**From:** Cyrus Naheedy <cnaheedy@gmail.com>  
**Sent:** Wednesday, September 13, 2017 11:01 AM  
**To:** kotlyar@a2gov.org; Hutchinson, Nicholas; Allen, Jane (Project Management); Bradley Parsons  
**Cc:** Coleman, Kayla; Linda Diane Feldt  
**Subject:** Pauline Blvd Resurfacing Feedback

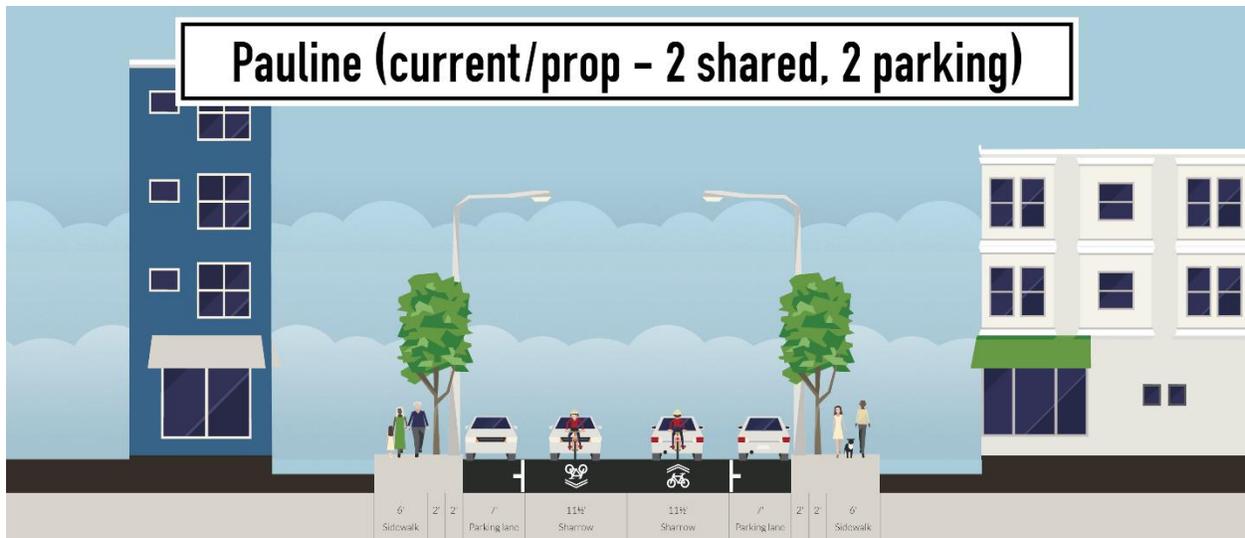
The first alternative is the current condition, and one that staff has proposed to keep: 2 parking lanes (7' each), and 2 shared travel lanes (11.5' each).

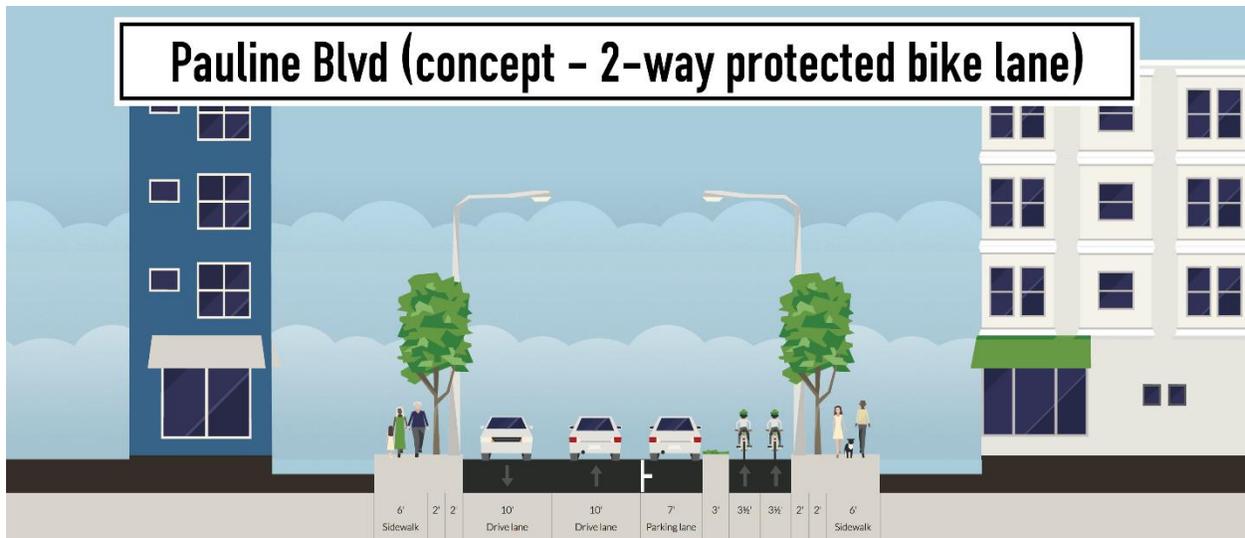
The second alternative is one the city has also discussed: removing the north parking lane to create 2 painted bike lanes (5' each), 2 vehicle travel lanes (10' each), and retaining the south parking lane (7').

The third alternative is one we did not discuss but that I wanted to share as a concept to consider. Instead of 10' of separate painted bike lanes, it would use the parking lane to protect a 2-way bike lane (3.5' each direction), with a 3' buffer lane (NACTO's recommended buffer distance between a parking lane and bike lane to help prevent dooring).
